Preah Vihear (Cambodia)

No 1224

Official name as proposed by the State Party: The Sacred Site of the Temple of Preah Vihear

CARTE ADMINISTRATIVE POUR LA GESTION PRÉPARÉE PAR LE ROYAUME DU CAMBODGE
EN VUE DE L'INSCRIPTION DANS LA LISTE DU PATRIMOINE MONDIAL

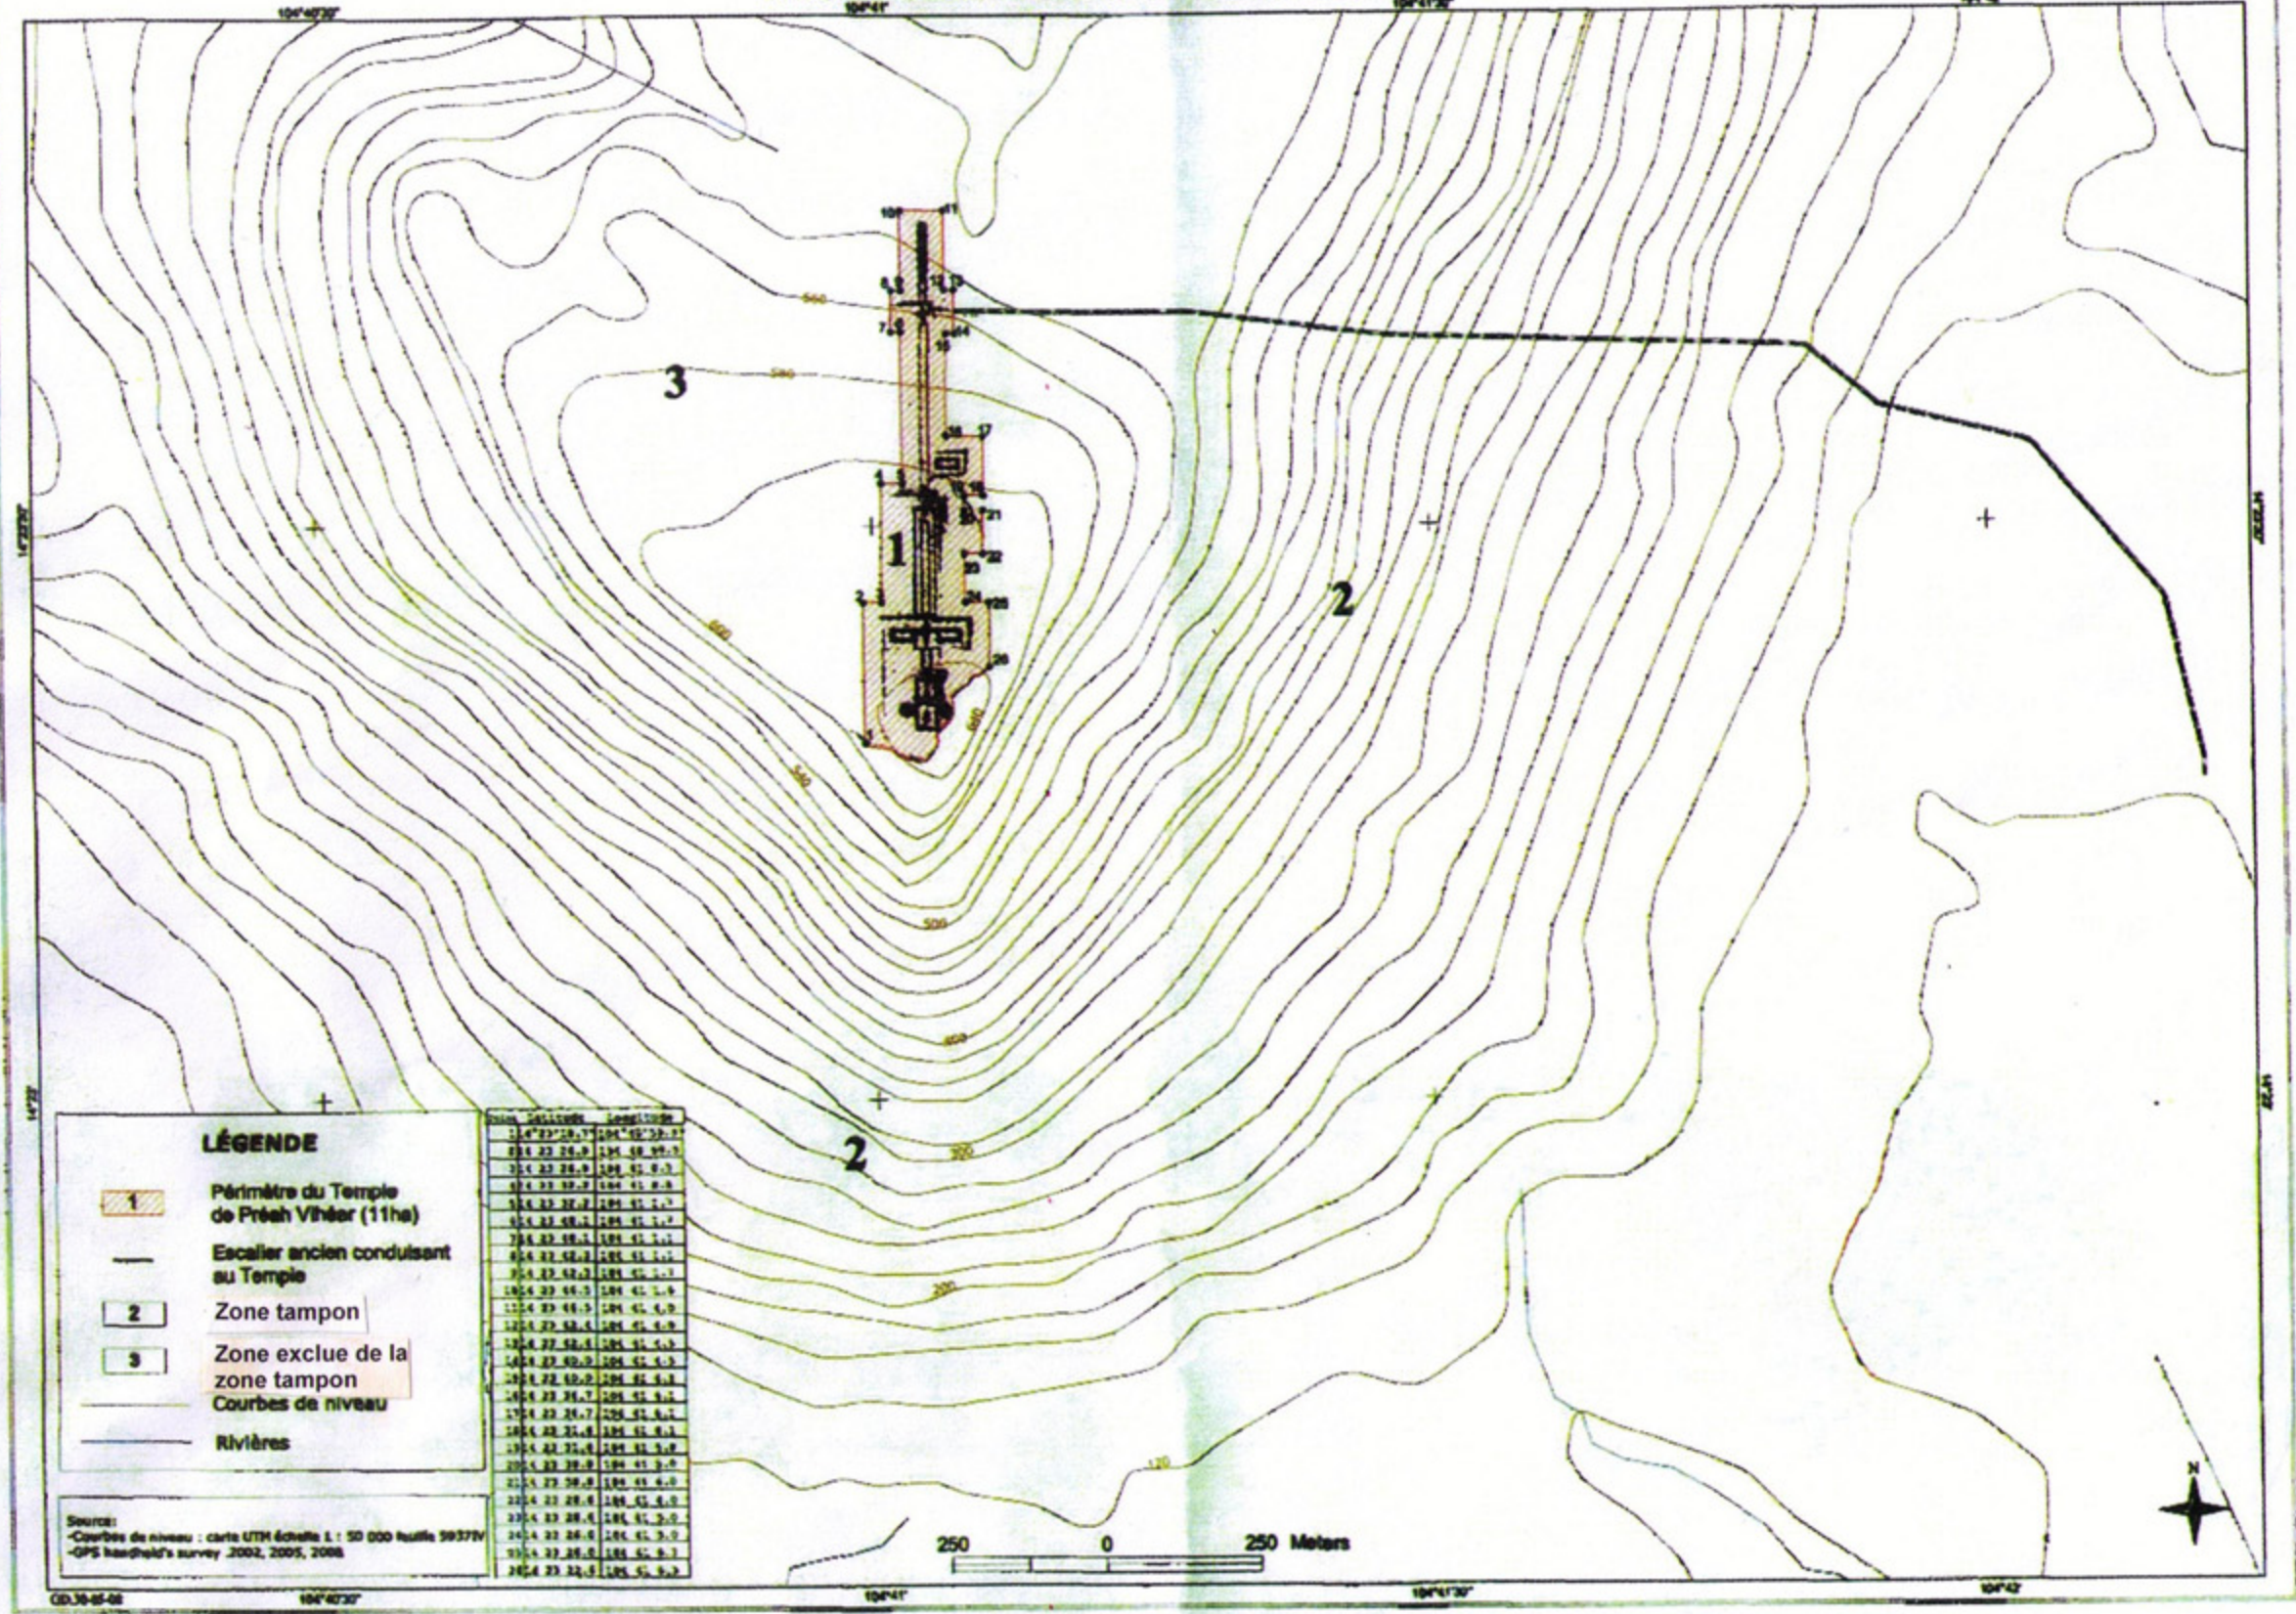
ICOMOS notes that although a map has been provided for the revised core area, this is at a small scale and needs to be augmented with a more detailed map. No detailed maps have been provided for the boundaries of the buffer zone and areas to the north and west, which will be subject to joint management arrangements between Cambodia and Thailand, (only general areas have been suggested).

ICOMOS wishes to acknowledge, and bring to the attention of the Committee, that the map submitted, with its undelineated buffer and joint management zones, is a

source of concern in terms of the long-term conservation and protection of the property;

- Detailed map of the core area and a map delineating the buffer zone;
- Updated Nomination dossier to reflect the changes made to the boundaries;
- Confirmation that the management zone for the property will include the core zone, buffer zone and joint north and west zone;
- Progress report on the preparation of the Management Plan, including the joint management plan to be prepared with the Thai authorities for the areas to the north and west of the core zone;
- A delineation of the areas to the north and west that will be covered by the joint management plan;
